John Wilkes House  
Drawing A201  
Proposed First Floor  
Scale 1:150 @ A3  
Revision A  
Issued 22.03.2024  
Issued for Planning  
Drawn by Enfield Council Architecture Team

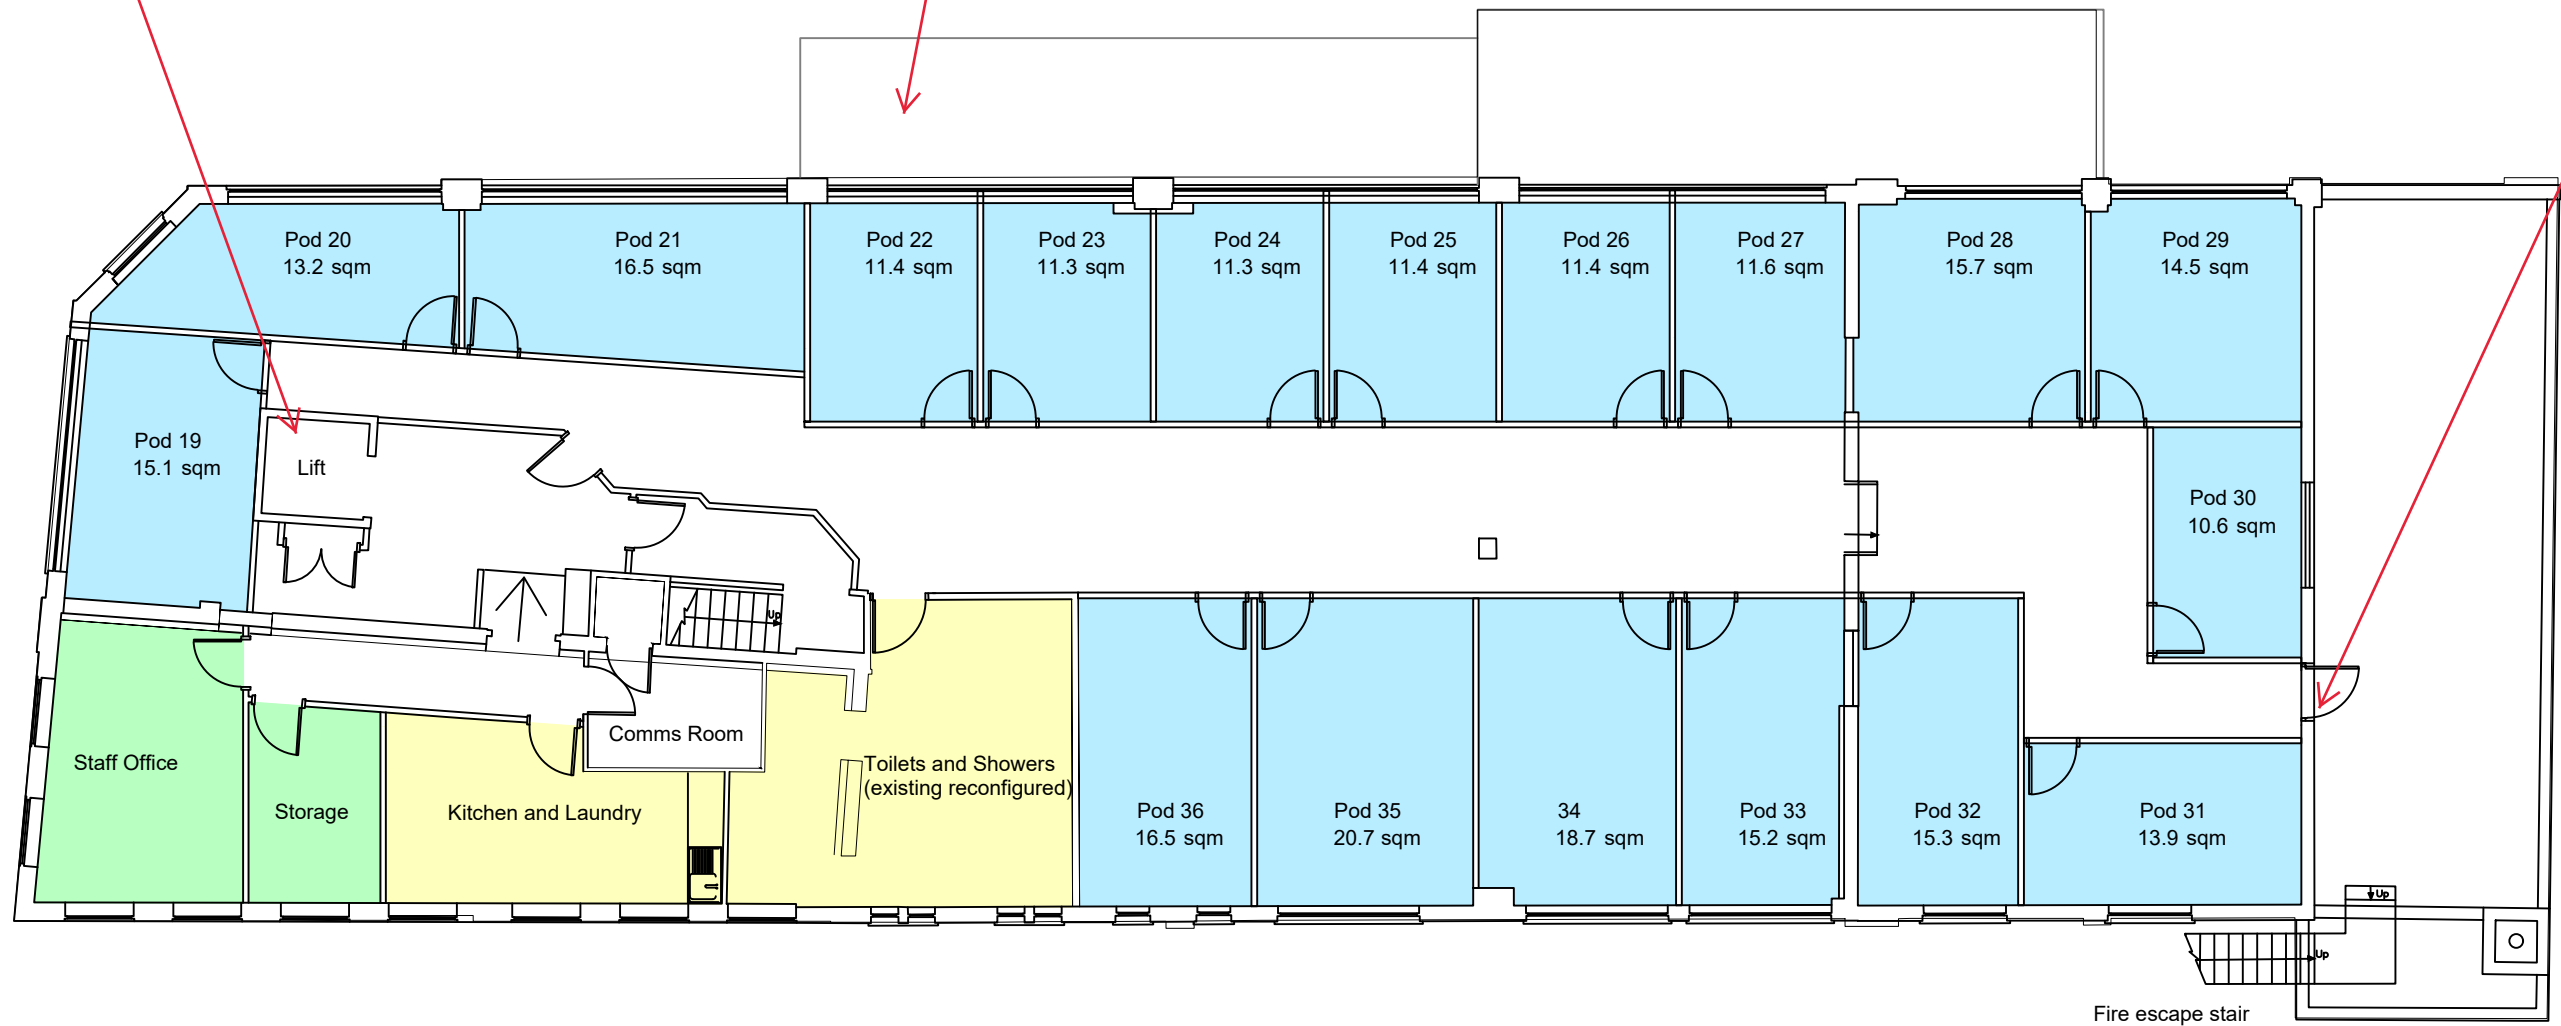
CCTV required in lift

Polycarbonate roof panels to be removed so area is not used in inclement weather

door alarmed and access restricted to escape during fire only
